## Technical Bulletin

Date: November 8, 2005

Subject: Carbo-Draught 1000 and Carbo-Draught Pro Compressor  
Outlet Tubing

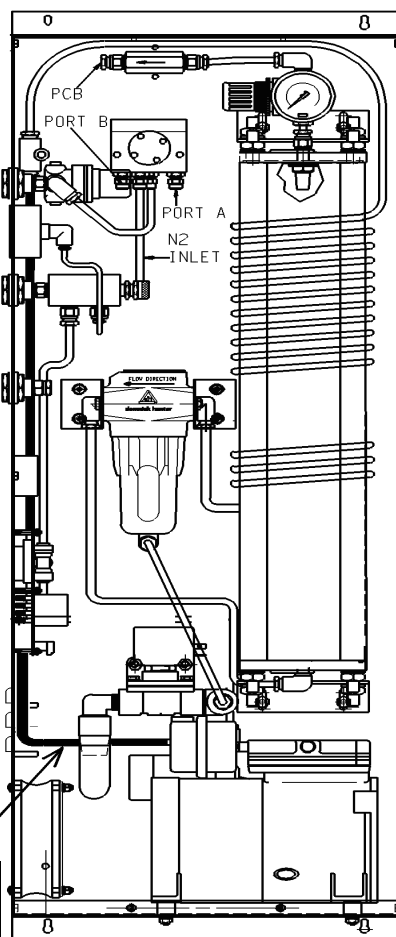
The compressed air in the Carbo-Draught 1000 and Carbo-Draught Pro models is routed out of the compressor head to a brass tubing connector at the top of the cabinet via a section of white 6mm tubing.

A hole may develop in this white tubing if it is allowed to rub against any metal part inside the cabinet.

If the brass fitting in the discharge port of the compressor is an elbow type, it should be changed to a straight fitting using the fitting supplied in the kit. The section of black shielding should be fitted over the new section of white tubing and the tubing should be routed horizontally across the cabinet from the compressor and up the left side of the cabinet to the brass tube connector. See diagram for new routing (shown in black).

If a hole does develop or if an upgrade is desired, Fizz part number **97021** should be used. This kit consists of: (1) 32 inch section of white tubing, (1) 18 inch section of black shielding material, (1) brass straight fitting, (2) brass tube nuts and ferrules.

After installation of new tubing, verify the tubing is clear of interference and secured with plastic cable ties. Check for leaks.
